**Re: Initial Submission Review – Prologis Park 70 EO2 - Sign Adjustment**  
Application Number: **DA-1396-20**  
Case Numbers: **2006-6044-02**

## *Initial Submission Review*

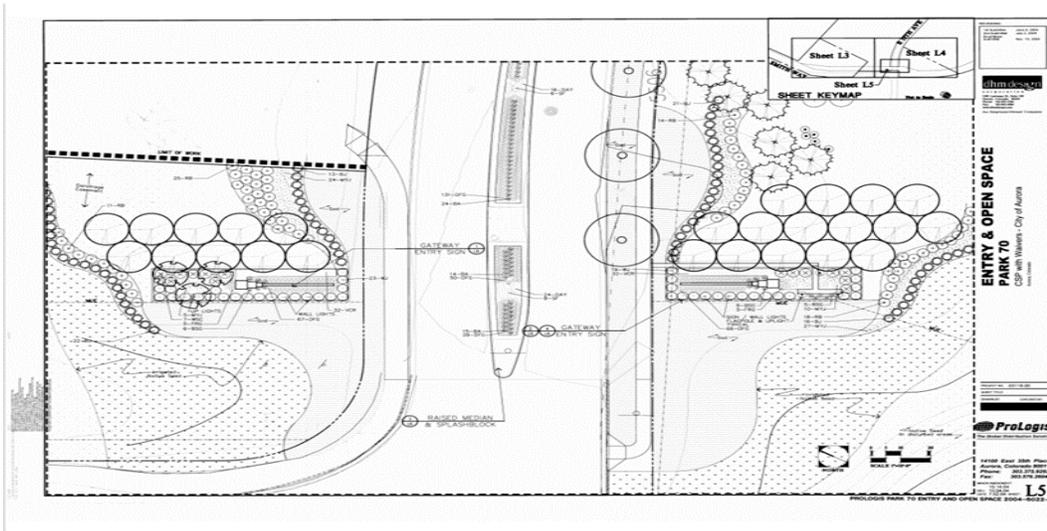
- 4A. Provide a revised landscape plan to address the impacts to the existing landscaping as relates to the installation of the new monument sign. The current proposal only indicates the replacement of one sign. There was a previous landscape plan approved for two existing monument signs, one on each side of the entry drive. See snippets below.

Is it the applicant's intent to remove the second sign altogether or replace both signs? The previous landscape plan will need to be updated to reflect the new monument(s) along with a detail that describes the materials, color and height. Reference the Entry & Open Space Park 70 CSP with Waivers Plan for the current signage and landscaping. Case Number 2004-6002-00.
